ADDENDUM #3

August 27, 2025

**CRAWFORDSVILLE READINESS CENTER MODERNIZATION
INDIANA NATIONAL GUARD
CRAWFORDSVILLE, INDIANA**

IFB NO: MDI-SAB-26-B-013

ABI 1
A350

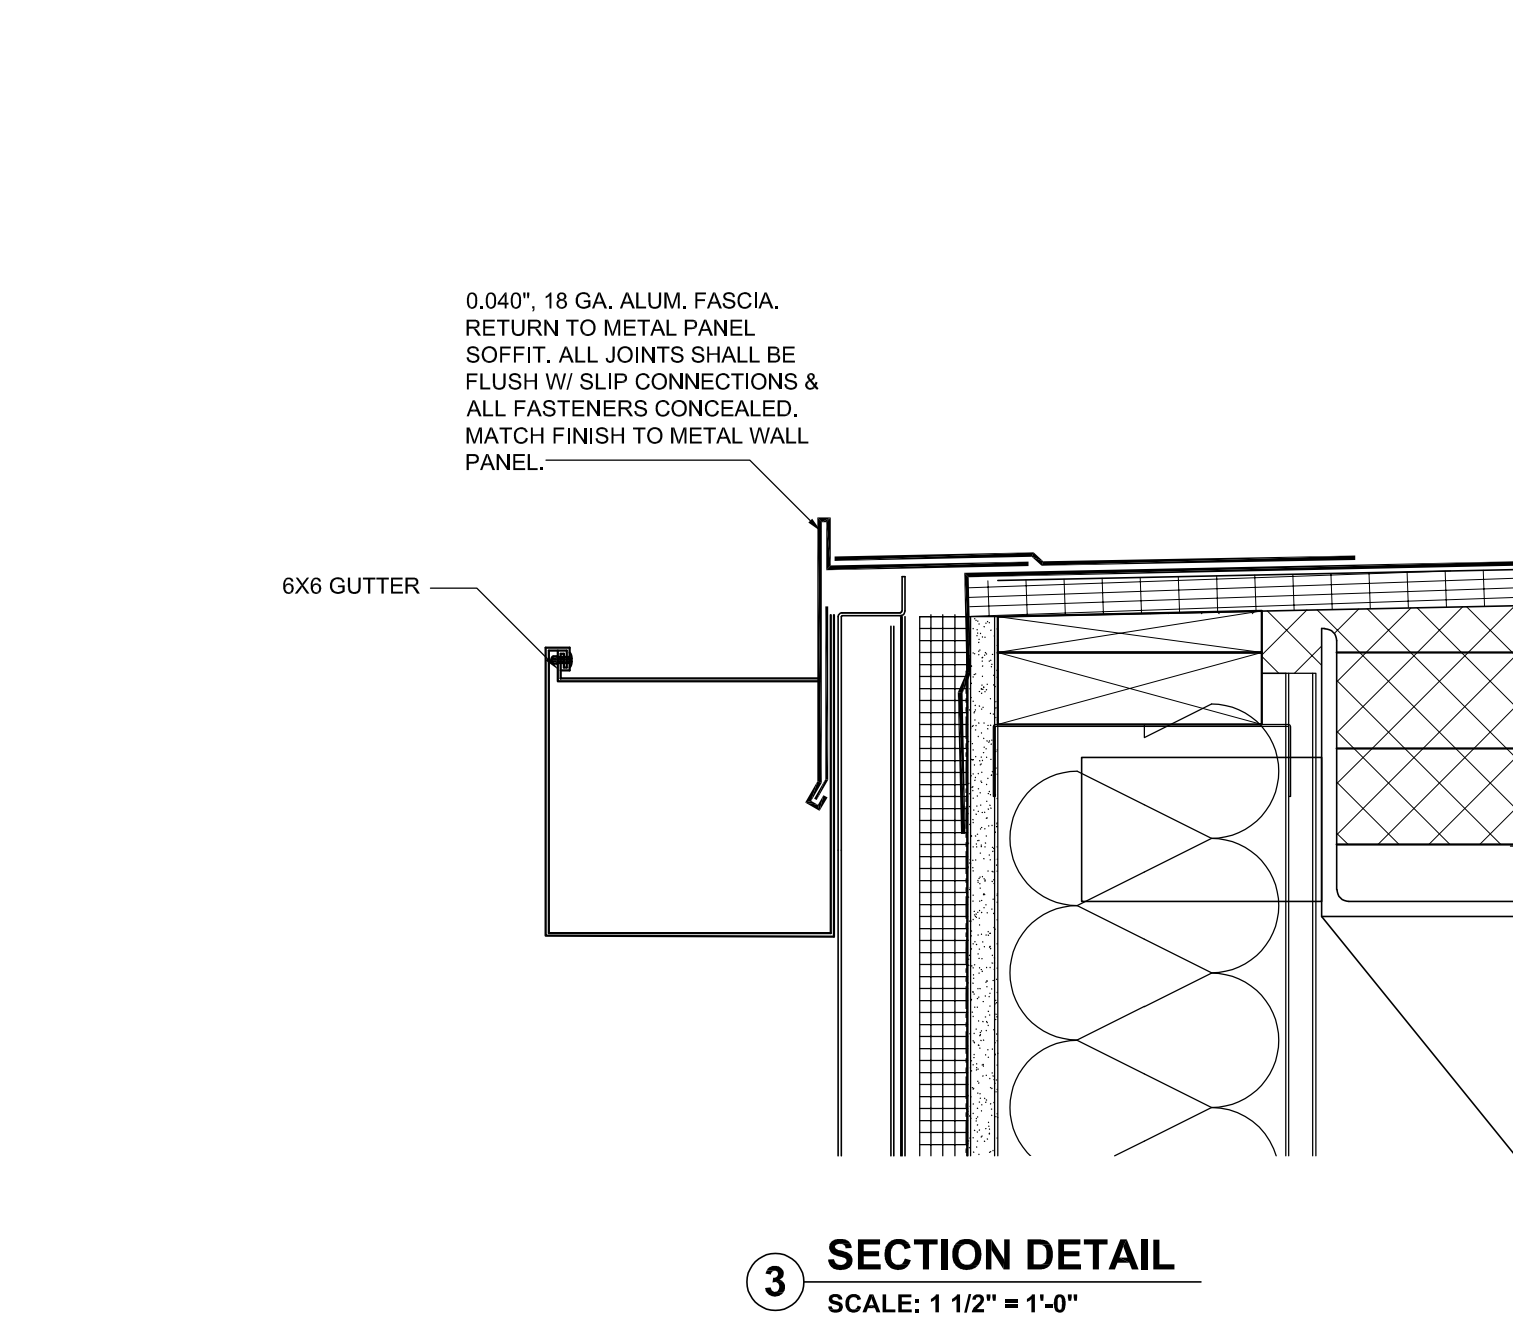
- 14. Sheet ABI 1 A350 – ABI 1 PLAN DETAILS
 - a. Revised Details 4 and 7
- 15. Sheets ABI 1 A360 – ABI 1 SECTION DETAILS
 - a. Add sheet to the Project
- 16. Sheet ABI 1 A802 – ABI 1 INTERIOR ELEVATIONS

15. **Question:** Section 07 95 00 Expansion Control lists model VF Series by Construction Specialties, however details 1/A350 and 6/A350 show SF Series by Construction Specialties. Should we bid per the details?

- Response:** More than one expansion joint style is required. Bid per the details.
17. **Question:** On ABI1 A110, it appears that Vestibule 100 has a drywall ceiling in there, but there is no tag saying what that ceiling is supposed to be. Please confirm this to be a drywall ceiling?

OVERALL
PLUMBING
FIRST FLOOR
PLAN

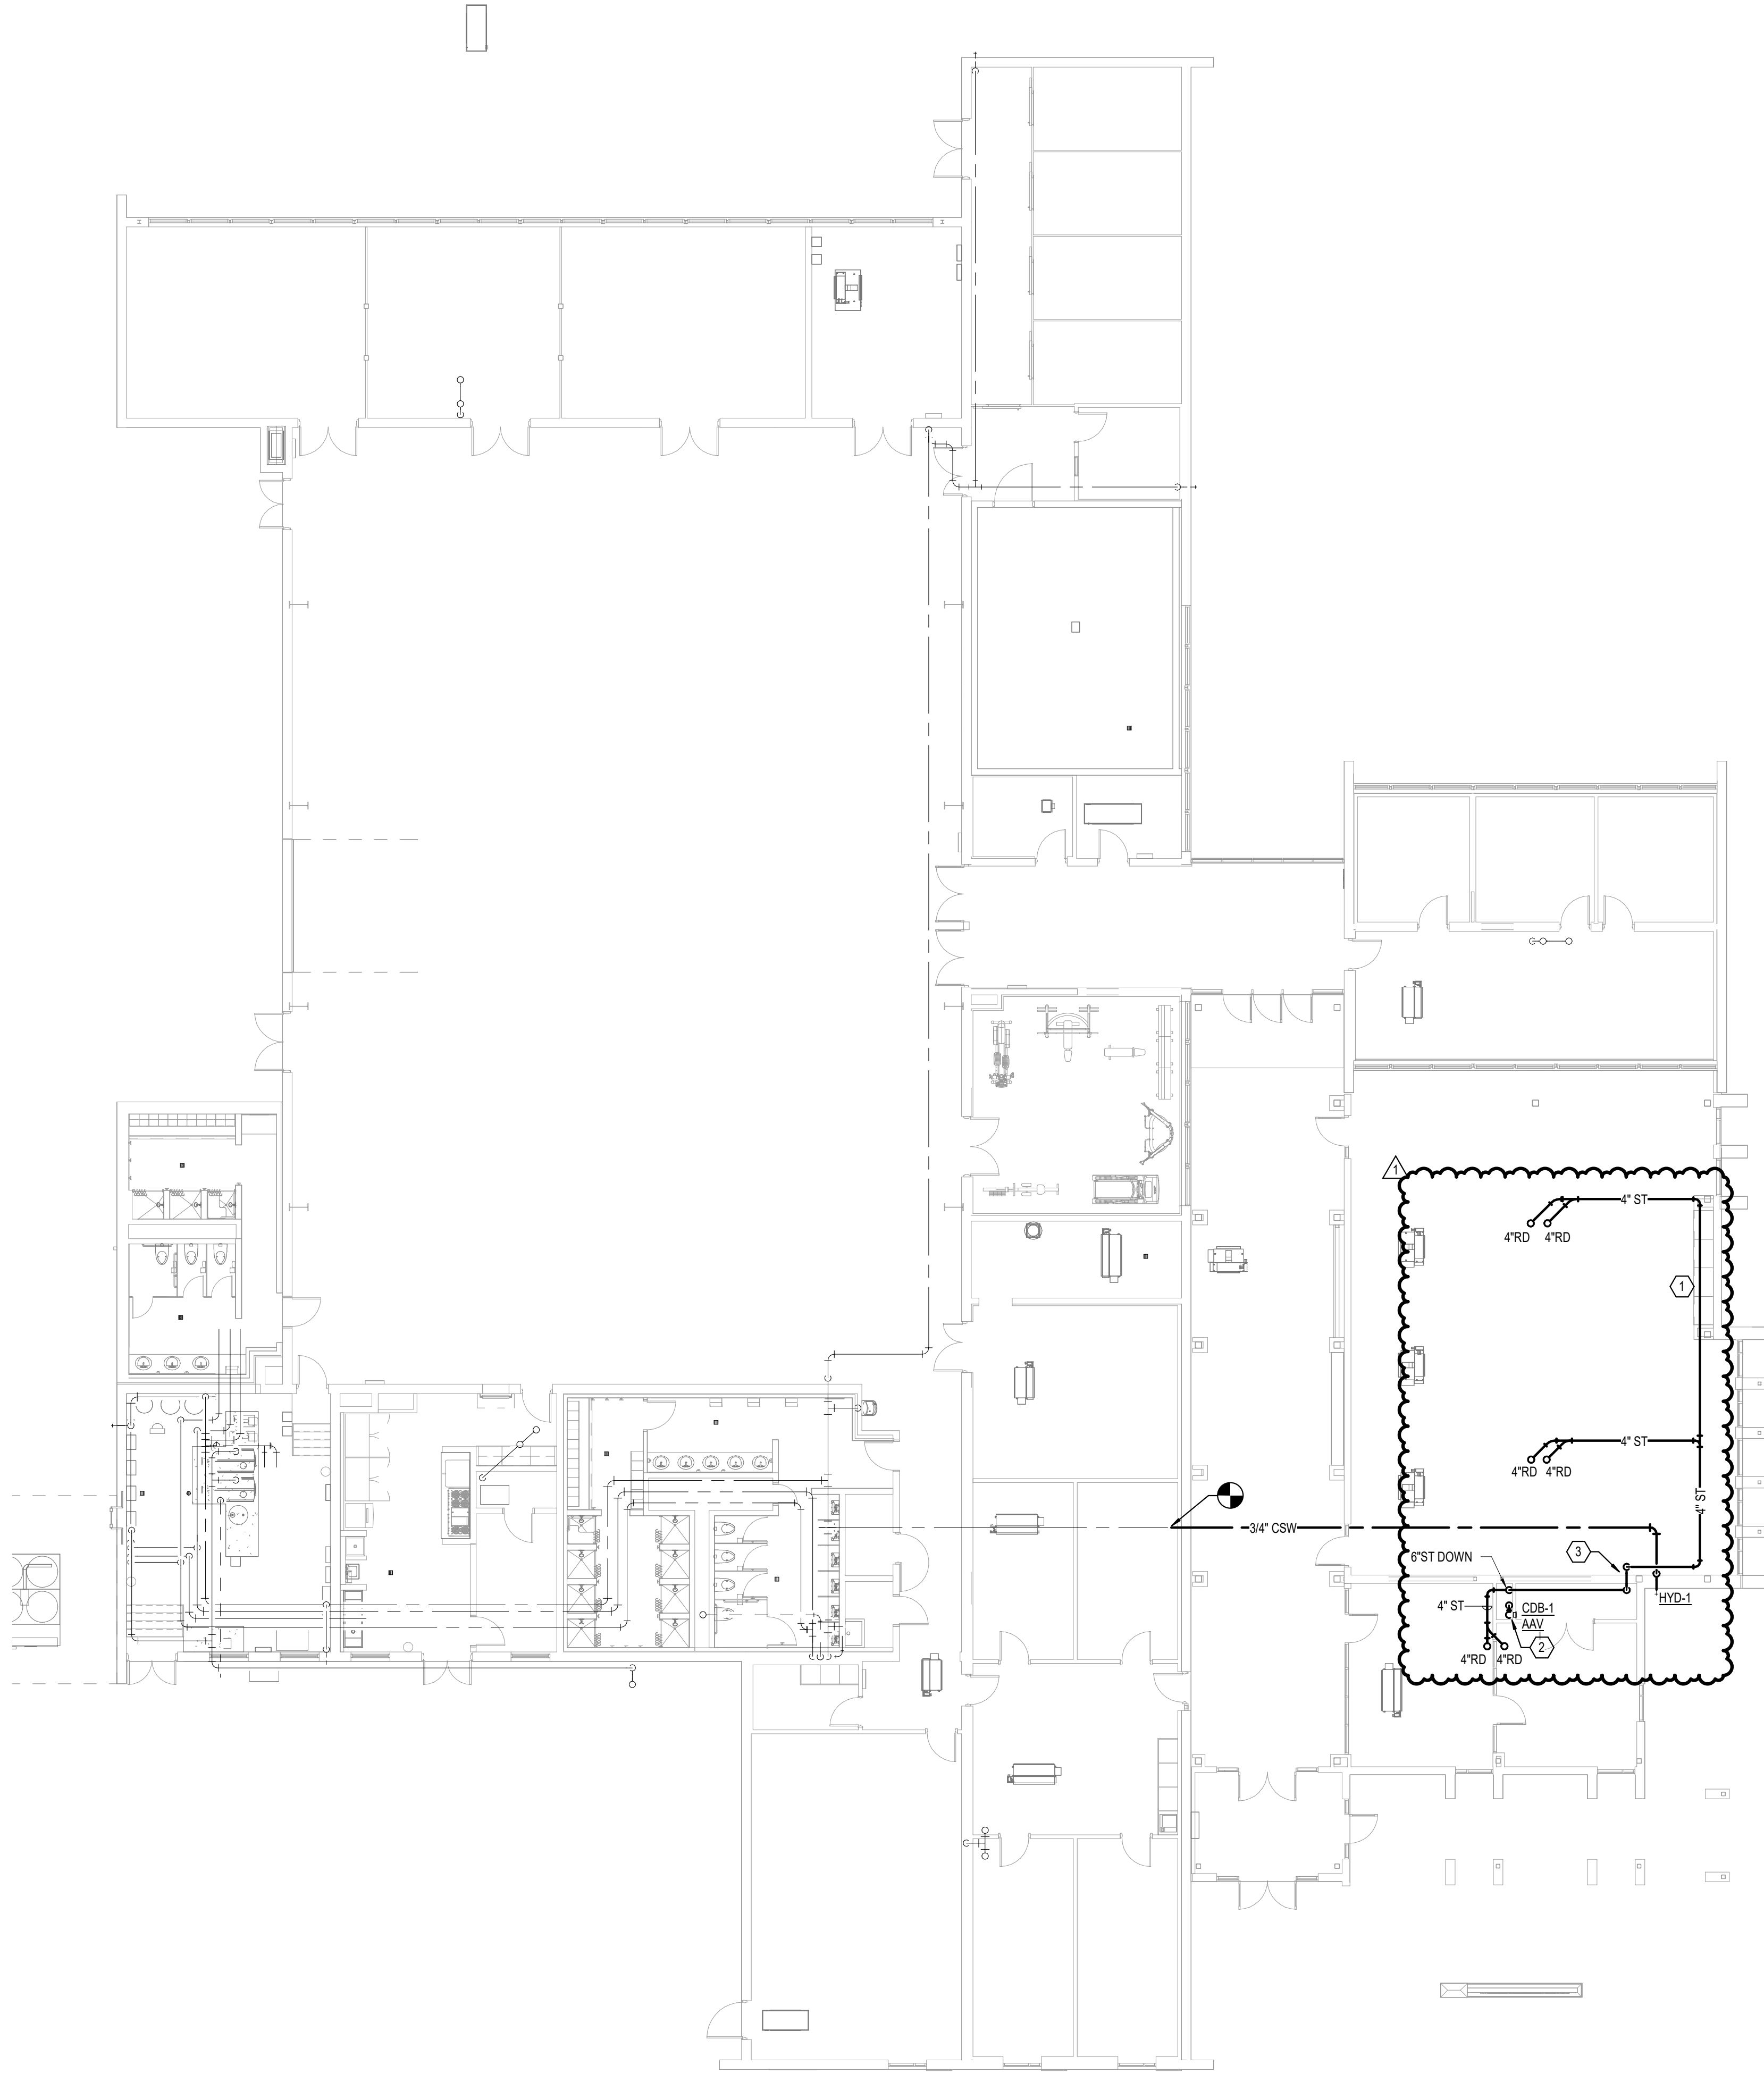
- a. Add sheet to the Project
- 17. ABI 1 P101 – OVERALL PLUMBING FIRST FLOOR PLAN
 - a. Reroute storm piping to avoid ductwork and mechanical equipment.

- b. Revise keynote 1.
- 18. ABI 1 EP101 – FIRST FLOOR POWER PLAN
 - a. Remove “VO” quad in CLASSROOM 105.
 - b. Add switches and power for motorized shades in CLASSROOM 105 and PLATOON COMMON AREA 106.
